EXAMINATION REPORT - 50-338/OL-85-02

Facility Licensee: Virginia Electric and Power Company  
Richmond, Virginia 23261

Facility Name: North Anna

Prior to the exit meeting, the examiners met with W. Shura, D. Hawkins, L. Edmonds, and R. Buck to review the written examination and facility comments. The following are the NRC responses to the facility comments and recommendations of Enclosure 4.

## QUESTION 2.19 (1.00)

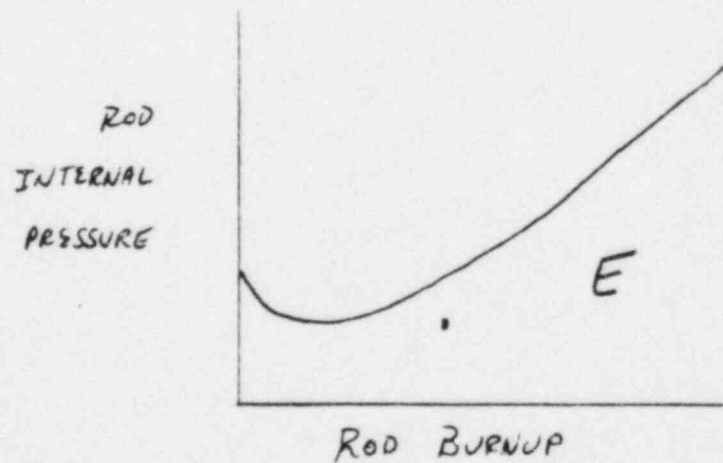
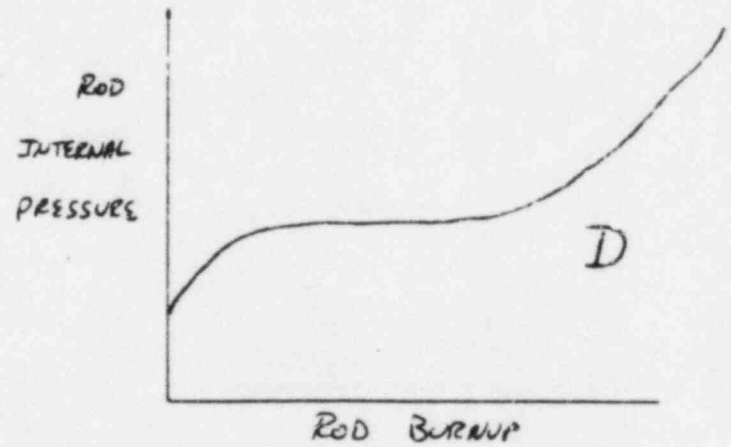
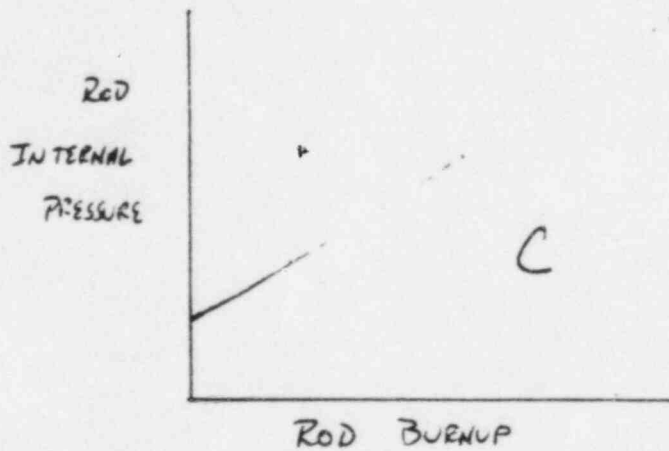
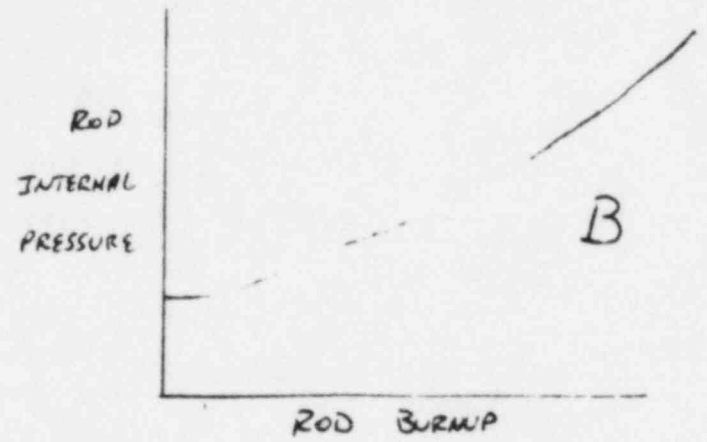
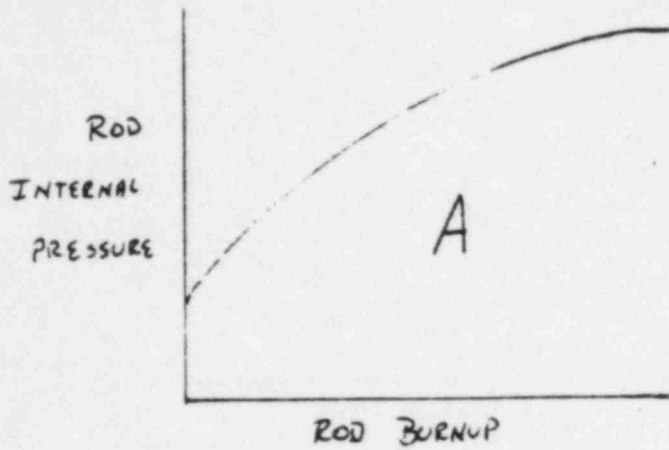
- (8) Question 2.19 - We disagree with the comment but agree with the recommendation. Knowledge of rod internal pressure buildup is important operator knowledge due to its impact on fission product poison leakage and structural strength of the individual fuel rods. However, conflicting curves given in lesson plan NCRODP 88.1 and in NAPS FSAR Fig. 4.2-5 could lead to some confusion as to which curve is the correct choice. Therefore, the question was deleted.
